BDCP Comments  
Ryan Wulff, NMFS  
650 Capitol Mall, Suite 5-100  
Sacramento, CA 95814

**SUBJECT: Comments on the Bay Delta Conservation Plan and Environmental Impact Report/Environmental Impact Statement**

Figure 23. South Delta Diversion at Banks

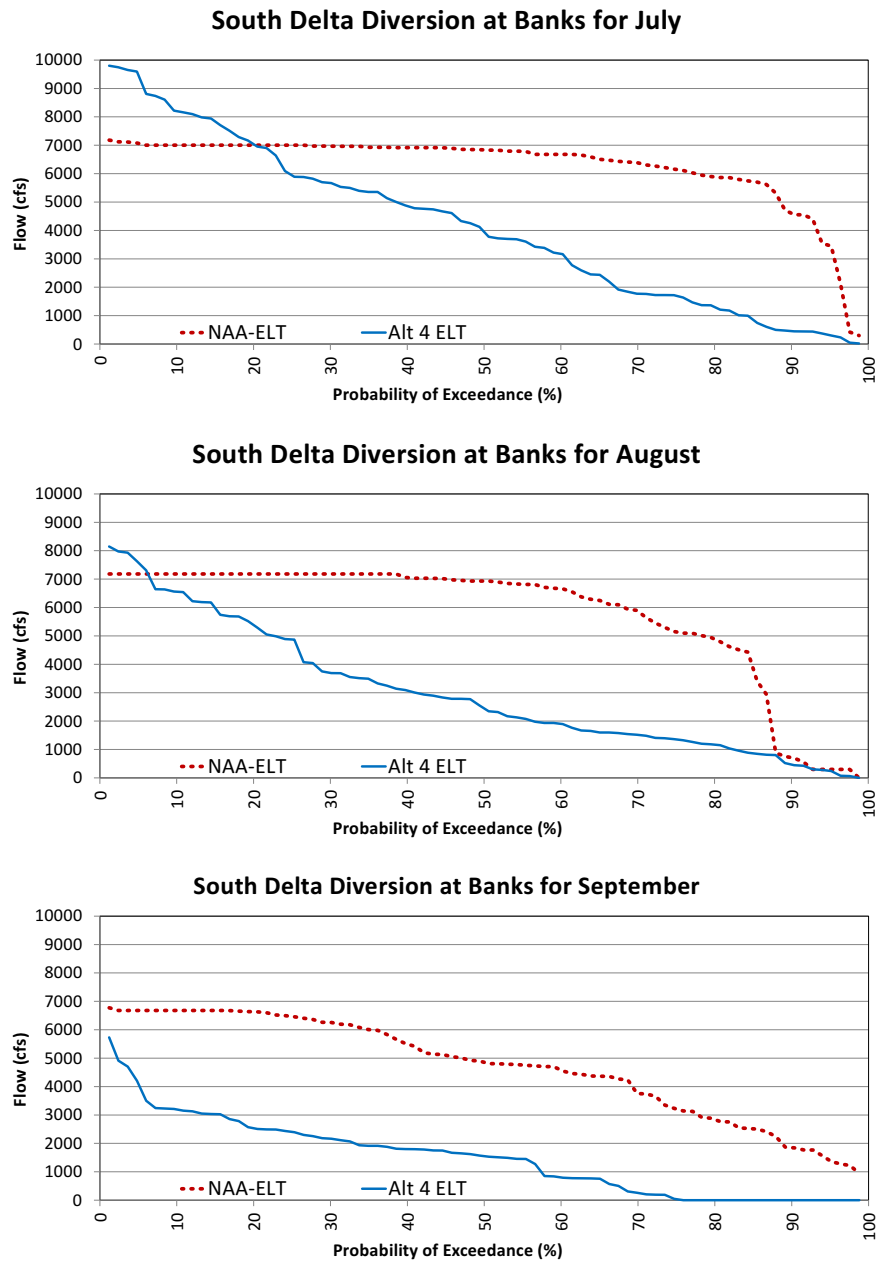
South Delta Diversion at Banks is not limited to existing permit capacity of 6,680 cfs and pumping may reach full capacity of 10,300 cfs in July, August, and September. Figure 23 contains exceedance probability charts of South Delta Diversion at Banks for July, August, and September. The chart for July shows SDD at Banks exceeding existing permit capacity 20% of years, in August this occurs in about 7% of years. There are South Delta diversions at Banks 25% of the time in September while diversions from the Sacramento River may range from 2,500 cfs to 7,500 cfs.

**Figure 24. Delta Outflow Change (Alt 4-ELT minus NAA-ELT)**

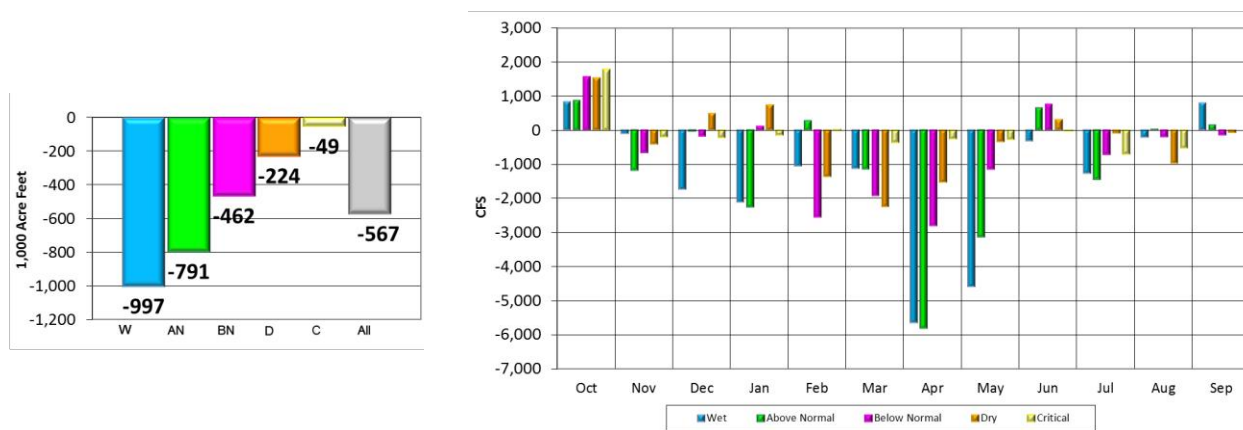
Figure 24 illustrates a comparison of Delta outflow between the NAA-ELT and Alt 4-ELT. Decreases in Delta outflow are the result of the CVP and SWP ability to increase Delta exports in Alt 4-ELT. The apparent increase in Delta outflow in October is partially due to additional export restrictions though Old and Middle River flow requirements. However, the increase in October Delta outflow is also due to an unrealistic operation of the Delta Cross Channel. The additional export restrictions cause the flow standards imposed at Rio Vista to be the controlling point in CVP and SWP operations; the water quality standards are all being met and do not require

flows above the amount needed to satisfy the Rio Vista standard. Meeting the Rio Vista flow standards without closing the Delta Cross Channel gate results in releasing more water from upstream reservoirs than would otherwise be necessary. This occurs because a certain amount of the water released to meet the Rio Vista flow standards would flow into the Central Delta at location of the Delta Cross Channel gate. This water would not make it to Rio Vista and therefore would not be counted towards meeting the Rio Vista flow standards. However, due to the BDCP model's assumed restrictions on exports at this time, this water could not be pumped from the South Delta facilities and thus ends up as "extra" Delta outflow. By closing the Delta Cross Channel gate, the operators would assure that all of the water released to meet the Rio Vista flow standards would be counted towards those standards. The BDCP model's assumptions that the Delta Cross Channel gate would not be closed are not practical or a sensible operation as the operators confirmed they would close the gate during these conditions to avoid the unnecessary loss of water supplies (as was done in October and November 2013). The assumption in the BDCP model to maintain the gate in the open position causes it to overstate the amount of Delta outflow.

**Figure 60. NDD, and Sacramento River Flow**

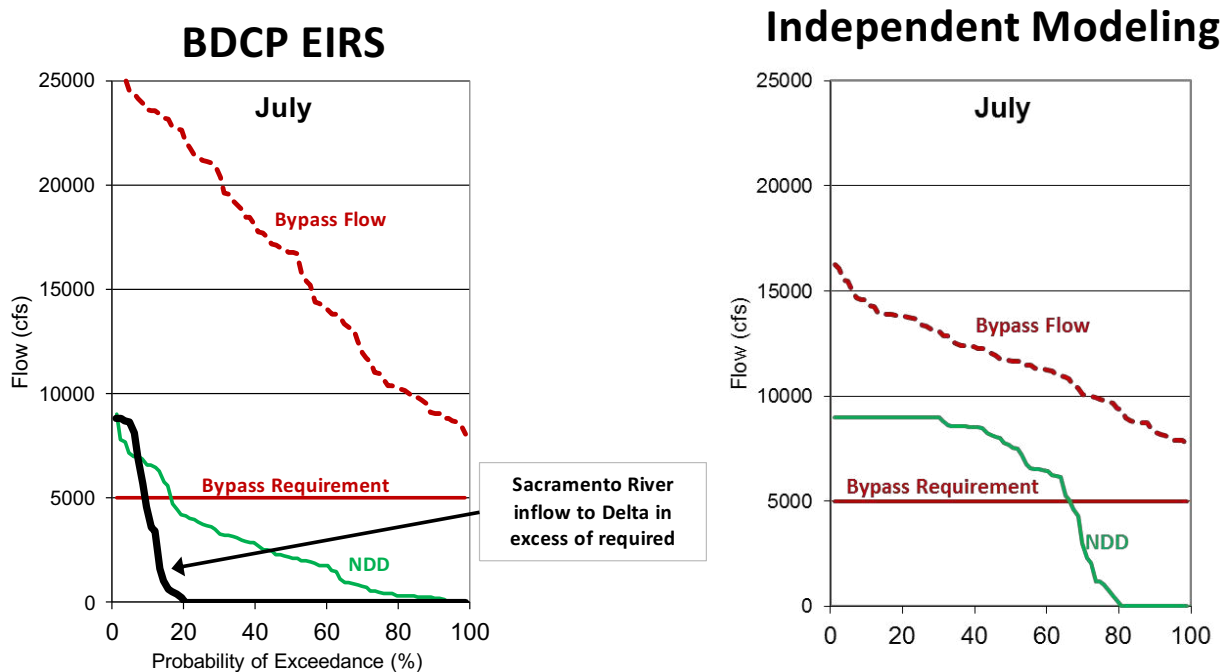
Independent modeling shows greater NDD during July and other months because the BDCP EIRS modeling includes artificially high Sacramento River bypass flow requirements. Figure 60 contains exceedance probability plots of Sacramento River required bypass, Sacramento River bypass flow, NDD, and excess Sacramento River flow to the Delta. As can be seen in Figure 60, bypass flow is always above the bypass requirement. The BDCP version of CalSim sets a requirement for Sacramento River inflow to the Delta that the independent modeling does not need in order to satisfy Delta requirements, therefore the NDD is higher in the independent modeling.

**Figure 61. Sacramento River below Hood**

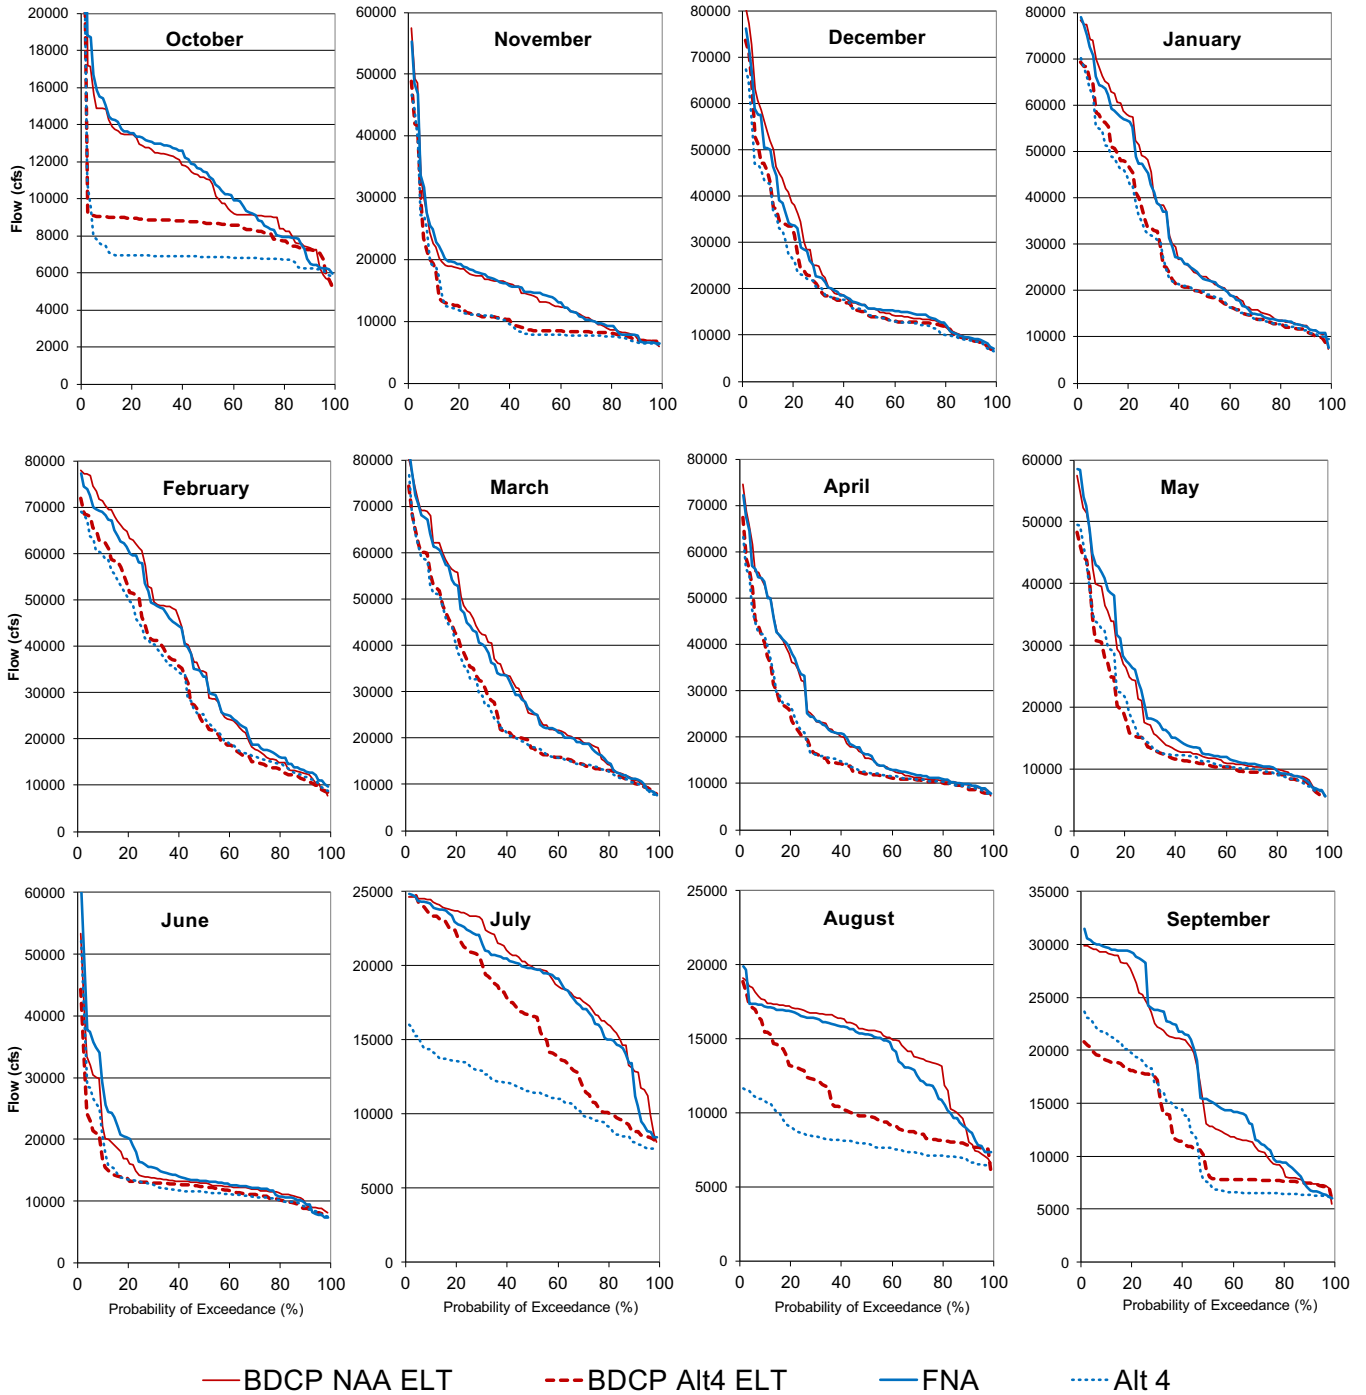
Figure 61 contains monthly exceedance probability plots for Sacramento River below the NDD for the following scenarios: 1) BDCP NAA-ELT, 2) BDCP Alt 4-ELT, 3) independent modeling FNA, and 4) independent modeling Alt 4. The most significant differences in flow changes occur in October, July, August, and September. Changes in Sacramento River flow entering the Delta are a key indicator of changes in interior Delta flows, water levels, and water quality.

In the independent modeling September flows are reduced by about 6,100 cfs while BDCP modeling shows a reduction of about 5,300 cfs. The independent modeling shows Sacramento River flow entering the Delta to be about 7,000 cfs 50% of the time, BDCP modeling show Sacramento River flow is about 8,000 cfs 50% of the time.

**Figure 62. Flow through Delta Cross Channel and Georgiana Slough versus Sacramento River Flow at Hood**

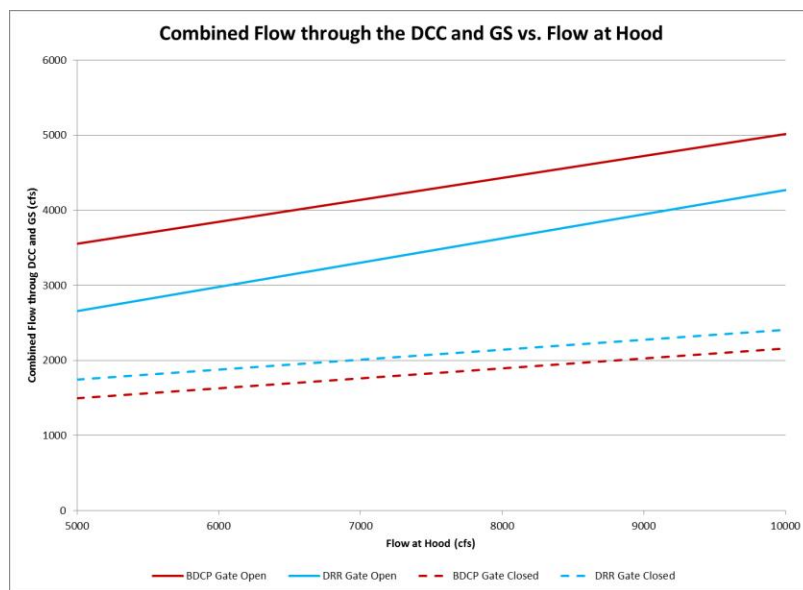
In CalSim, flow through the DCC gate and Georgianna Slough from the Sacramento River into the Central Delta is assumed to be linearly dependent on flow at Hood. There are two linear relationships; one is used when the DCC gates are closed, and the other is used when the DCC gates are open. The 2013 SWP Delivery Reliability Report CalSim II modeling, and therefore our independent modeling, used different linear flow relationships than BDCP. The BDCP and 2013 DRR (and independent) flow relationships for both the open and closed gate conditions are compared in Figure 62. When Sacramento River flow at Hood is in the range from 5,000 cfs to 10,000 cfs the balance between Hood flow, required flow at Rio Vista, and DCC gate operation can affect upstream reservoir operations, SOD exports, and Delta outflow. As shown in Figure 62, given the same flow at Hood and DCC gates closed, the independent analysis will show slightly higher flow into the Central Delta (12% to 17% difference for the Hood flows in the 5,000 cfs to 10,000 cfs range). With DCC gates open the same flow at Hood, the independent analysis will show lower flow into the Central Delta (-15% to -25% difference for the Hood 5,000 cfs to 10,000 cfs range). Figure 63 and Figure 64 show the differences through the DCC and combined flow through the DCC and Georgiana Slough.

**Figure 1: Reverse Flow Events per Year with Advective Transport Exceeding 0.9 Miles for DWR Modeling Studies, 1974-1991 Hydrology.**

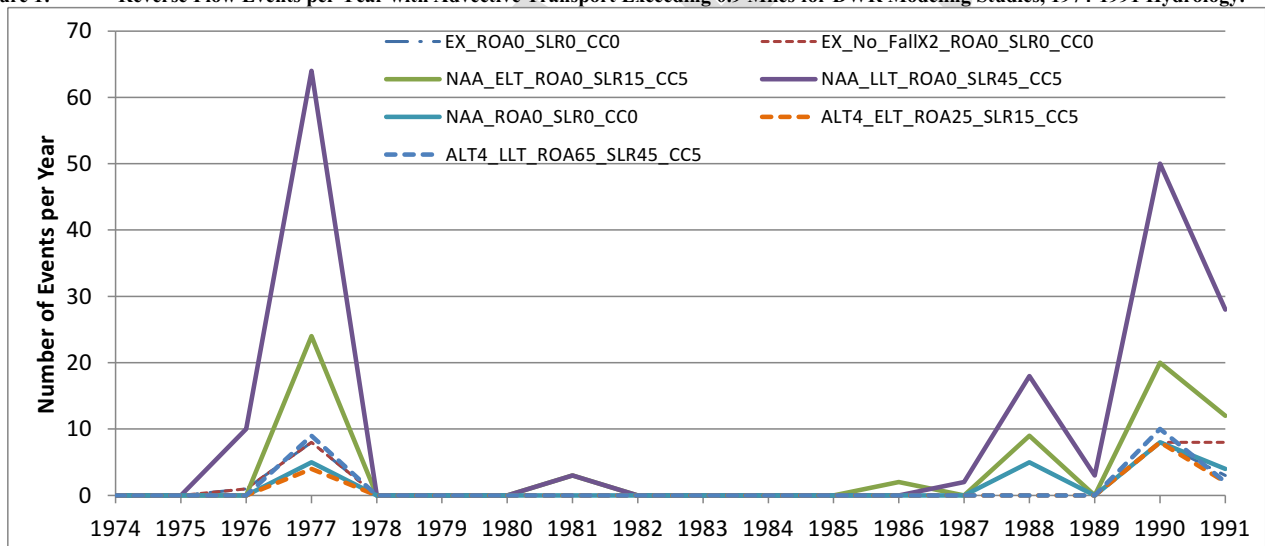
- DWR DSM2 model output was provided for each of the seven simulations listed in Table 1. Model results provided spanned October 1, 1974 through September 20 1991 on 15-minute intervals. Table 3 presents the number of reverse flow events with advective transport exceeding 0.9 miles that would cause a shutdown of FRWP for each of the seven DWR model simulations. Figure 1 shows the number of reverse flow events per year over the hydrologic period simulated.

Figure 2: Reverse Flow Incidents per Year with Advective Transport Exceeding 0.9 Miles for MBK Modeling Studies, 1921-2003 Hydrology.

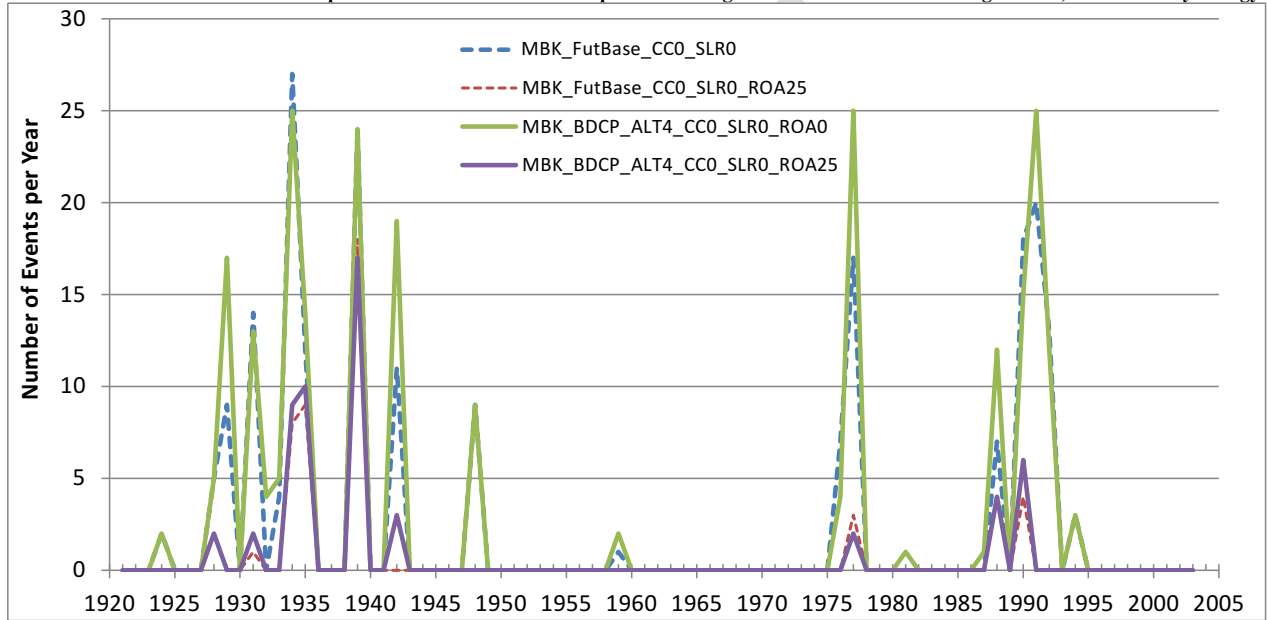
- Additional modeling performed by CCWD simulated the full hydrologic period that was simulated with Calsim2<sup>25</sup>. This modeling provided additional clarifying information regarding the effect of the two components of the project isolating the effect of restoration. Four DSM2 model simulations were analyzed as described in Table 1. The number of reverse flow events for the full 83-year period of record and shorter 19-year period that would result in a shutdown of FRWA are presented in Table 4. The distribution of the number of reverse flow events per year is plotted in Figure 2.

**Figure 3: Sacramento Valley Water Year Hydrologic Classification Frequency for Calsim2 Hydrologic Period (1921-2003, 83 years) with DSM2 Hydrologic Period (1976-1991, 16 years).**

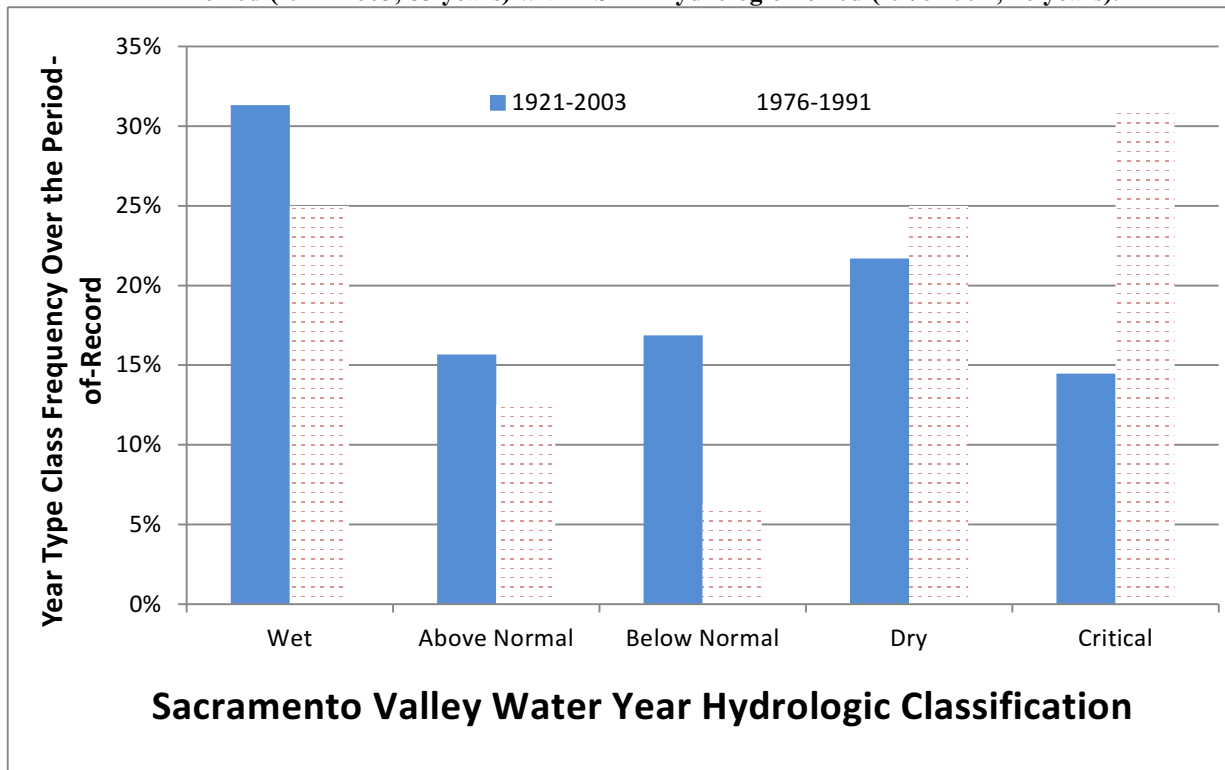
- Table B-9 DSM2 Inputs page 5A-B73 reports that the period simulated is a 16-year period 1976 through 1991. This represents a shortened hydrologic period simulated relative to the Calsim2 model that simulates an 83-year period from 1921 through 2003. The shortened 16-year period covers the two main drought periods<sup>27</sup>; however, this shorter 16-year period is skewed towards drier year types (see Figure 3). On the basis of the Sacramento Valley Water Year Hydrologic Classification, the Dry and Critical year types are the most frequent (at 56%) relative to Wet, Above Normal, and Below Normal year types (44%) in the 1976 through 1992 period. For the longer period of hydrology simulated with Calsim2, the wetter year types (*i.e.* Wet, Above Normal, and Below Normal) account for 66% of the 83-year period whereas the Dry and Critical year types account for 37%. While reverse flow events are expected to occur in the drier year types which are over-represented in the shorter 16-year period, the purpose of the impacts analysis is to discern the impact of the proposed project as compared to the no project or no action. Considering that the project effects are greatest in the wetter year types when regulatory constraints on the system are less restrictive to project operations, the approach of simulating a shorter period that is relatively dry means that the impacts analysis is based on a period in which the project operation is more constrained. Furthermore, since DSM2 boundary conditions are available for the full 83-year period of record, the reason to limit the DSM2 model to a shorter and drier hydrologic period seems arbitrary. Simulating a longer hydrologic period with more variation in hydrologic conditions seems more appropriate to base the analysis of potential impacts of the proposed project.
